Roads Safety Audit

Intersection of McAuleys Lane and Mullumbimby Road, Myocum

Ardill Payne and Partners (APP) has engaged GeoLINK to undertake a Road Safety Audit (RSA) for the concept design of the proposed upgrade works at the intersection of McAuleys Lane and Mullumbimby Road in Myocum.

Drawing no.	Rev	Date	Title
10431 SK01	D	17/06/2022	Concept Intersection Layout

Intersection Layout
1:500 @ A1

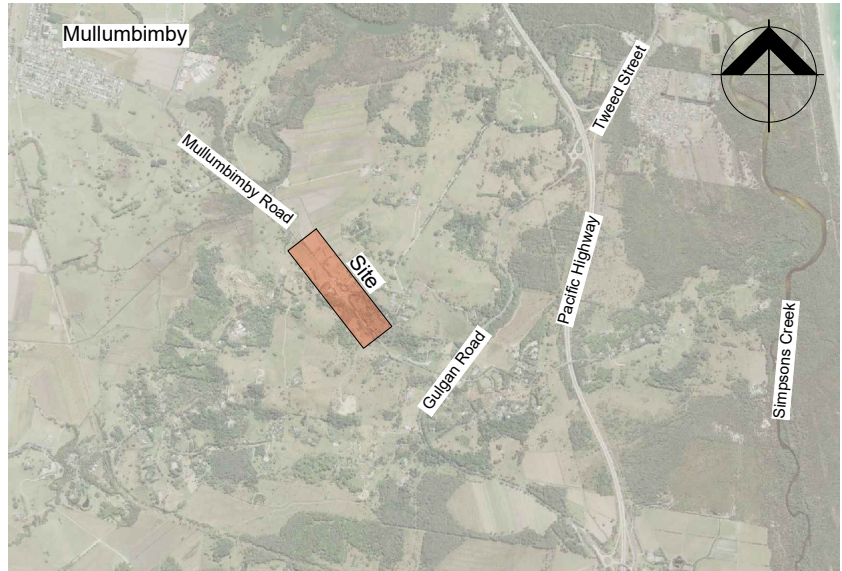
Audit findings	Risk Ranking	Client	
		Accept	Comments
<p>1. Exiting McAuleys Lane</p> <p>Vehicles travelling in the auxiliary left turn lane may prevent motorists exiting the McAuley Lane intersection from seeing northwest bound through traffic.</p> <p>There is a risk that a motorist will proceed through the intersection unaware that there are vehicles travelling towards them in the through-lane at speed on a downhill gradient. This may result in a rear-end or left near collision (e.g. vehicles turning left out of McAuleys Lane) or a right near collision if the vehicle exiting McAuleys Lane was turning right. The latter has the potential to result in a fatal injury given the likely speed of the through traffic. However, the low volumes of traffic utilising the auxiliary left turn lane reduce the expose to this hazard.</p>	<p><i>Rare Fatal</i></p> <p>High</p>	N	There is no accident history as far as we know related to this issue. Left turn in volumes are low. Downgrade in the approach to the left turn would assist in sight distance (seeing over the approaching car). Leave turn lane as is.

<p>2. Crest on Mullumbimby Road between McAuleys Lane and The Saddle Road</p> <p>The proximity of the crest on Mullumbimby Road to the intersection of The Saddle Road and Mullumbimby Road significantly limits the sight distance available for vehicles exiting The Saddle Road. There is a risk that a motorist will proceed through the intersection unaware that there are vehicles approaching from the northwest at speed.</p> <p>This may result in a rear-end or left near collision (e.g. vehicles turning left out of The Saddle Road) or a right near collision if the vehicle exiting The Saddle Road was turning right. The latter has the potential to result in a fatal injury given the likely speed of the through traffic.</p> <p>It is noted, however, that this risk is an existing safety issue and the proposed works do not in any way exacerbate the situation.</p>	<p><i>Possible Serious</i></p> <p>High</p>	N	Noted, but issue not related to McAuleys Lane intersection design.

<p>3. Vegetation at The Saddle Road intersection</p> <p>Vegetation on the eastern side of The Saddle Road intersection limits the sight distance available for vehicles exiting The Saddle Road. There is a risk that a motorist turning right out of The Saddle Road will proceed through the intersection unaware that there are vehicles approaching from the southeast at speed. This may result in a right near collision.</p> <p>It is noted, however, that this risk is an existing safety issue and the proposed works do not in any way exacerbate the situation.</p>	<p><i>Possible Serious</i></p> <p>High</p>	N	Noted, but issue not related to McAuleys Lane intersection design.

Audit findings	Risk Ranking	Client	
		Accept	Comments
<p>4. Bus Stop on Mullumbimby Road</p> <p>The bus stop and shelter on Mullumbimby Road is located shortly after a crest vertical curve.</p> <p>Bus drivers will not be able to see if there are patrons waiting at the bus shelter until the bus is over the crest. There is a risk that a bus travelling northwest will need to break sharply to stop at the shelter. This may result in a rear-end collision involving a vehicle travelling closely the behind the bus at 80 km/h.</p>	<p><i>Rare Serious</i></p> <p>Medium</p>	Y	<p>Issue accepted. Will discuss further with Council and bus companies. May not be practical to relocate bus stop</p>
<p>5. Proposed raised island at driveway to No. 110 Mullumbimby Road</p> <p>The proposed raised concrete island appears to be located directly behind the southeast-bound travel lane on Mullumbimby Road. The loss of shoulder space creates a pinch point for cyclists travelling along Mullumbimby Road in a south-easterly direction.</p> <p>There is a risk that a cyclist will abruptly move from the shoulder into the travel lane and be struck by traffic travelling at speed in the same direction.</p>	<p><i>Unlikely Fatal</i></p> <p>Extreme</p>	Y	<p>At design stage, island will be designed to allow shoulder users to pass</p>

<p>6. Driveway to No. 110 Mullumbimby Road – Comment Only</p> <p>The site visit revealed significant safety issues associated with the proximity of the crest on Mullumbimby Road to the driveway providing access to No. 110 Mullumbimby Road. Although there is sufficient sight distance available to the right (northwest), the crest severely limits sight distance to the left (southeast).</p> <p>The measures to prevent right turns in or out of this driveway proposed in the concept design remove the exposure to this hazard.</p>	<p>Comment only</p>	-	<p>Noted</p>
<p>7. Proposed G1-207 at driveway to 130 Mullumbimby Road – Comment Only</p> <p>The proposed replacement of the 'Side Road Intersection' sign located approximately 100 m northwest of McAuleys Lane with a larger G1-207 sign may impede sight distance for drivers exiting the driveway.</p> <p>Caution should be taken to ensure this sign is located so as not to adversely impact the sight distance of motorists existing the driveway.</p>	<p>Comment only</p>	Y	<p>At design stage, sign will be located with consideration of sight distance from driveway</p>
